## 2.2 Bushy Park Management Plan Draft 2014-2024

## 2.4 Pre - Application Consultation February 2024

## 2.5 Consultation with Sport England - 28.03.2024

Proposed Pre App scheme submitted to Sport England for comment.

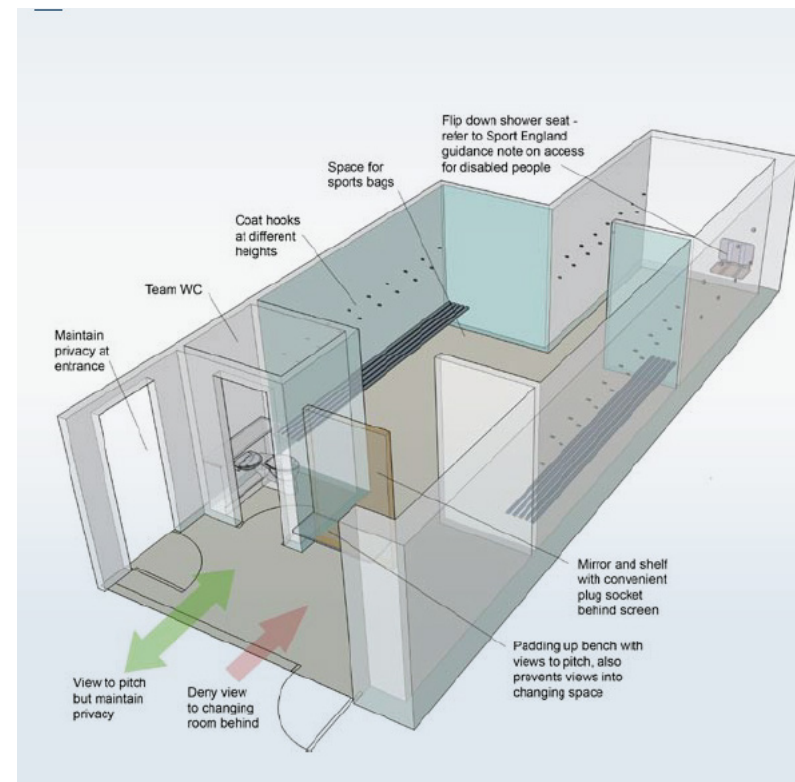
- Sport England acknowledged that the proposed Pavilion would be sited on the footprint of the former Pavilion and the much-needed replacement would meet the needs of the local sports community, meeting exception 2 of Sport England Playing fields policy.

- A site plan was produced post consultation to demonstrate no impact on the pitches adjacent to the Pavilion, no loss to the outfield over the existing, which has concrete hardstanding at present to the front of it. The footprint will not and does not move forward onto any area of the pitch. The present pitch boundary is limited, so the footprint would not come any further forward from the existing area of hard standing. The site plan is shown throughout the report.

- Sport England recommended attention be given to the glass windows of the players' changing rooms. These will be treated with privacy glass to maintain the privacy of all players using the facility.

- The minimum size of the changing rooms was stated as 20sqm. All changing rooms have been designed and sized accordingly to meet governing body standards as shown on the Ground Floor plan shared later in the report.

- A private shower cubicle was recommended to be included in all officials changing rooms, (2 x 1m), this has been addressed.
- For every 3-4 changing spaces, a shower point needs to be provided. The Proposed scheme provides these facilities.

- Sport England raised the need for access to the First floor for DDA users, a requirement the scheme already addresses. A lift has been located in close proximity to the gathering space at the main entrance of the building allowing access for all abilities to the social area at first Floor.

- For club houses that serve more than one pitch it is recommended that a unisex accessible/ assisted change Room be provided with a shower, WC and change bench. Post consultation was located off the main entrance. An accessible change shower seat has been positioned in the shower areas as shown in the image opposite, taken from the ECB design guidance for club houses.

The plans were fully reviewed alongside all the design guidance provided and the proposed scheme now demonstrated in this report reflects this. Given the constraints of the footprint, the restriction to build like for like area/ scale/ volume of the former Pavilion, the design works hard to address all the needs of the club to ensure a future proof scheme, aligned to design guidance and governing bodies requirements.
